Access Audit Site Report

Caprock Canyons State Park and Trailway

Accessibility Evaluation

Inspection Date: 05/19/2022

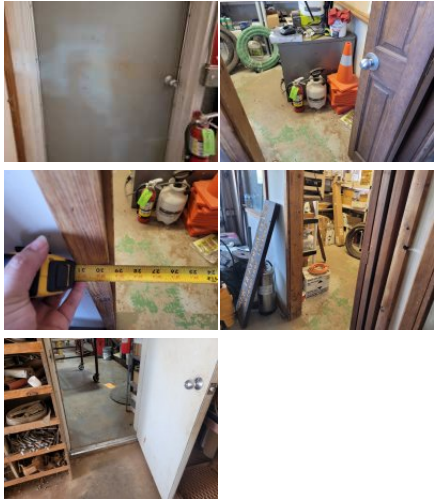
83	Headquarters Area: Discovery Center Restrooms	[34.413268, -101.05962 64]	An item or items project more than 4 inches into the circulation path. Wall-mounted objects that have leading edges between 27 inches and 80 inches from the floor must not project more than 4 inches into the circulation path. Protruding objects that extend to the floor or within 27 inches of the floor are cane detectable and are therefore not hazardous. Where it is necessary or desirable to have objects protrude from the wall, a manner of cane detection must be provided.	Discovery Center men's- hand dryer projects 5"	Relocate protruding objects or place cane detectable warning or bollard at foot of item.	2015 ABAAS Section: 307.2 2012 TAS Section: 307.2 2010 ADAS Section: 307.2	 	
84	Headquarters Area: Discovery Center Restrooms	[34.4132636, -101.0596 345]	The accessible route contains running slopes greater than 5 percent and cross slopes greater than 2 percent across the width of the walk and has not been constructed as a ramp (i.e. handrails, wheel guides, etc.). When the slope in the direction of travel of any walk exceeds 1 unit vertical in 20 units horizontal (5-percent slope), it must be constructed as ramp. Surface cross slopes must not exceed one unit vertical in 48 units. Horizontal (2-percent slope).	Discovery Center men's- 3.6% at drain	Correct or repair slope to max 2.08% in restroom.	2015 ABAAS Section: 403.3 2012 TAS Section: 403.3 2010 ADAS Section: 403.3

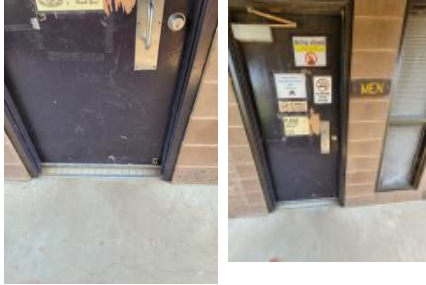
157	Lake Theo Day Use Area: Lake Theo - Bunkhouse	[34.4131286, -101.0670199]	The roof extends down too close to the route of travel. Any obstruction that overhangs a route of travel must be a minimum of 80 inches above the walking surface as measured from the bottom of the obstruction.	shelter 77.5"	Raise shelter roof to min 80", or pad object to prevent hazard in overhead clearance	2015 ABAAS Section: 307.3 2012 TAS Section: 307.3 2010 ADAS Section: 307.3

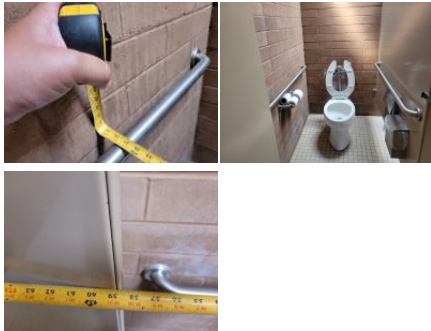
168	Lake Theo Day Use Area: Lake Theo - Men's Restroom	[34.4168415 , -101.06668 2]	An item or items project more than 4 inches into the circulation path. Wall-mounted objects that have leading edges between 27 inches and 80 inches from the floor must not project more than 4 inches into the circulation path. Protruding objects that extend to the floor or within 27 inches of the floor are cane detectable and are therefore not hazardous. Where it is necessary or desirable to have objects protrude from the wall, a manner of cane detection must be provided.	Hand dryer projects 5.25"	Relocate protruding objects or place cane detectable warning or bollard at foot of item.	2015 ABAAS Section: 307.2 2012 TAS Section: 307.2 2010 ADAS Section: 307.2

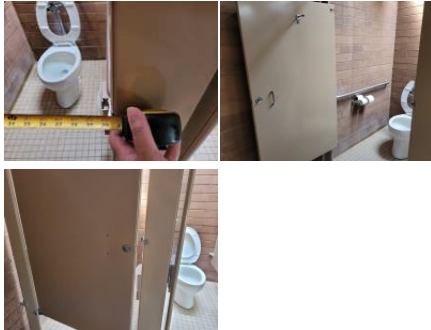
171	Lake Theo Day Use Area: Lake Theo - Women's Restroom	[34.4168382, -101.0666779]	The top rim of the sink is too high. All lavatories/sinks that are designated to be accessible shall be a minimum 17 inches in horizontal depth and mounted with the rim or counter edge no higher than 34 inches above the finished floor.	Sink 37" AFF	Lower sinks to max 34" above the finished floor (AFF) to front of rim.	2015 ABAAS Section: 606.3 2012 TAS Section: 606.3 2010 ADAS Section: 606.3

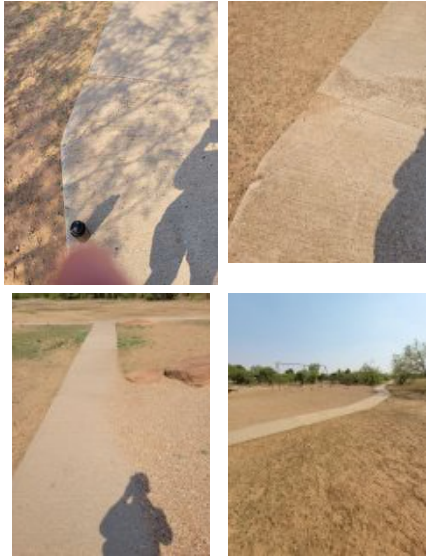
203	Honey Flat Camping Area: Honey Flat - Campsites 1-35	[34.4209778 , -101.05434 1]	The operable part is not accessible because there is not adequate clear floor space for either a forward or side approach. The clear floor or ground space shall be 30 inches minimum by 48 inches minimum.	Bench in clear ground space at sign	Remove, or relocate storage in CFS at fixtures and operable parts along the AR.	2015 ABAAS Section: 305.3 2012 TAS Section: 305.3 2010 ADAS Section: 305.3		
204	Honey Flat Camping Area: Honey Flat - Campsites 1-35	[34.421088, -101.05280 27], [34.4201587 , -101.0540 633]	There is no accessible route to the road or path. At least one accessible route shall connect accessible buildings, accessible facilities, accessible elements, and accessible spaces that are on the same site.	Lacks AR for 5 feet at start of sidewalk near site 25, site 15	Create an accessible route with crushed stone or other outdoor material from walkway to path or roadway.	2015 ABAAS Section: F206.2.2 2012 TAS Section: 206.2.2 2010 ADAS Section: 206.2.2

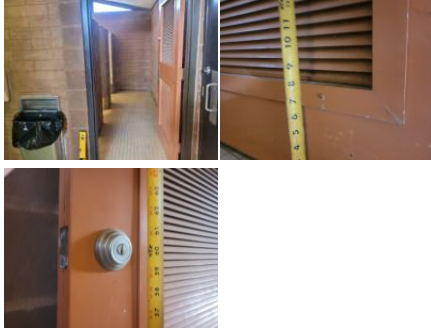
246	Honey Flat Camping Area: Honey Flat - Women's Restroom	[34.4210831, -101.0543693]	The top rim of the sink is too high. All lavatories/sinks that are designated to be accessible shall be a minimum 17 inches in horizontal depth and mounted with the rim or counter edge no higher than 34 inches above the finished floor.	Sink 36.75" AFF	Lower sinks to max 34" above the finished floor (AFF) to front of rim.	2015 ABAAS Section: 606.3 2012 TAS Section: 606.3 2010 ADAS Section: 606.3
